RECEIPT DATE: 10/11/24 **ONSITE SEWAGE DISPOSAL SYSTEM** 587829

APPROVAL DATE: 12/13/2023 **PERMIT: NEW CONSTRUCTION** A \_\_\_\_\_

PROPERTY ADDRESS: 2511 Daisy Road

**ONSITE SEWAGE DISPOSAL PLAN,  
PROFILE, NOTES & DETAILS  
WEIKEL PROPERTY - LOT 1  
2511 DAISY ROAD**

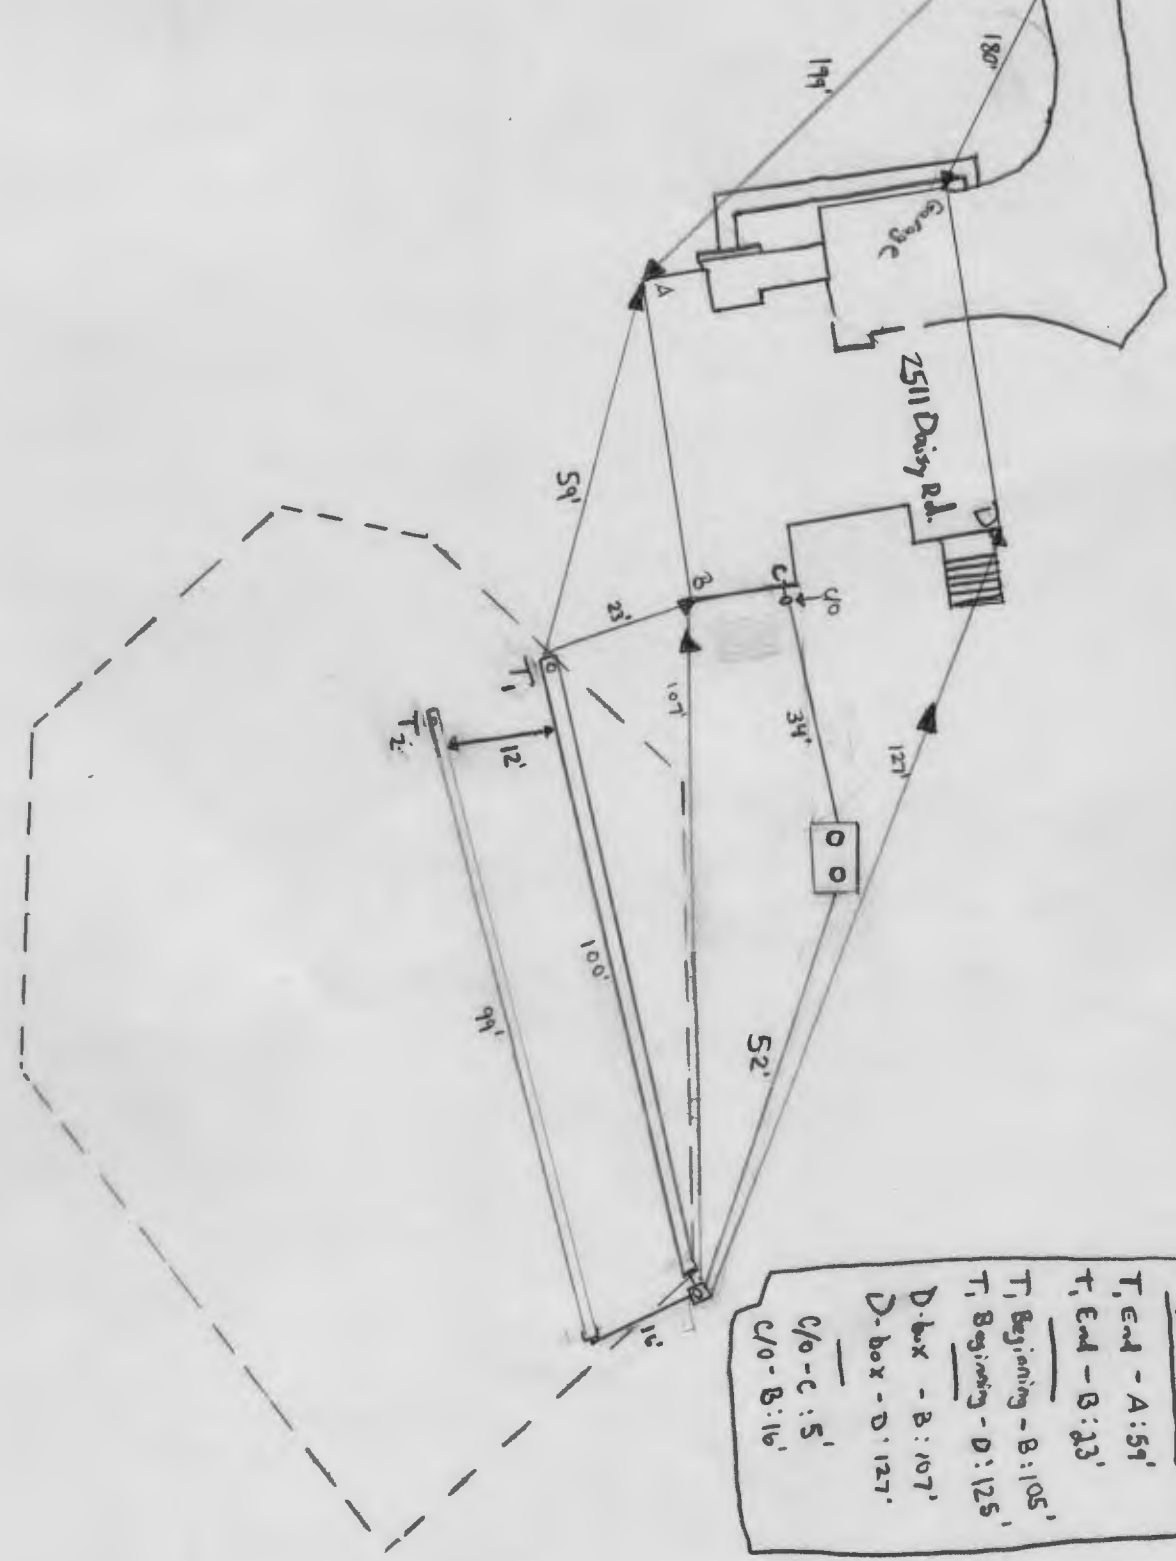
11/12/2024 Contractor dug the line from the septic tank to 5' from the house. Has about 2 1/2 full. Levelled D-box. The end of the 2nd trench has been completed - it is stoned and geotextile fabric has been added. Front baffle has been added to the ST. OK to backfill. MS

12/11/2024 - sewer out of house connected to c/o. installer bedding under pipe on to backfill. SP

11/7/24 Met with contractor on site. The stairs at the back of the house are

in the right of the house. The OSDS plan has this reversed. Engineer will have to revise the plan. Shot trench contours. Variance for both trenches is 3" Max. Contractor to remove silt fence that was put up directly over top of the 2nd trench. Plans to install ST today. Will be installing it to the left of current proposed location.

INSTALLATION NOTES: Trench lengths are per plan. MS/SP

11/7/24 Septic tank installed. It is level and sits 2.3' - 2.6' below grade. Contractor had to leave site to get additional supplies. He will be leaving the ST hole open overnight. MS 11/8/24 Contractor dug both trenches at 99' and 100'. The trench further away from the house has been stoned and geotextile fabric has been installed. Stone or Inlet depth at 2.5'. Contractor OK to backfill. Trench closer to house has been stoned. Geotextile fabric added for the first 50' of trench. For rest of trench. He will be receiving more on Monday or Tuesday next week. OK to backfill majority of trench. Inlet at 2.5'. Contractor OK to backfill ground tank so that it does not float over weekend. Back baffle of ST installed, but not front. Contractor will dig ST connection next week. Will leave area around d-box open over the weekend. MS

**DETAILED PLAN VIEW**

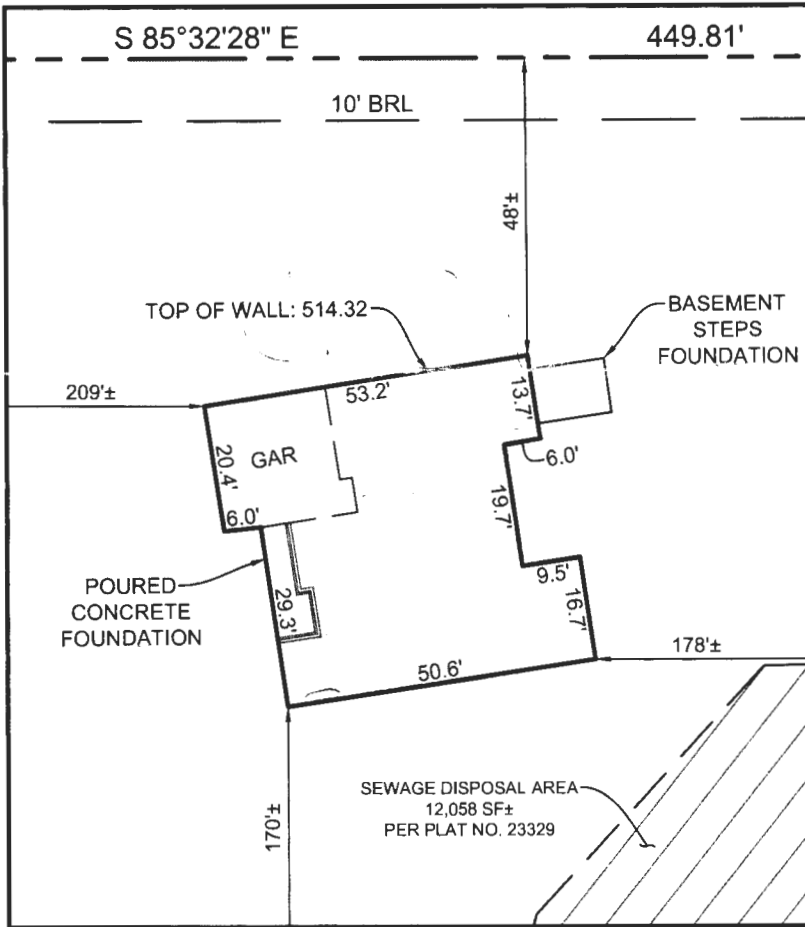
*Wall Check OK.  
gjb 10/11/24*
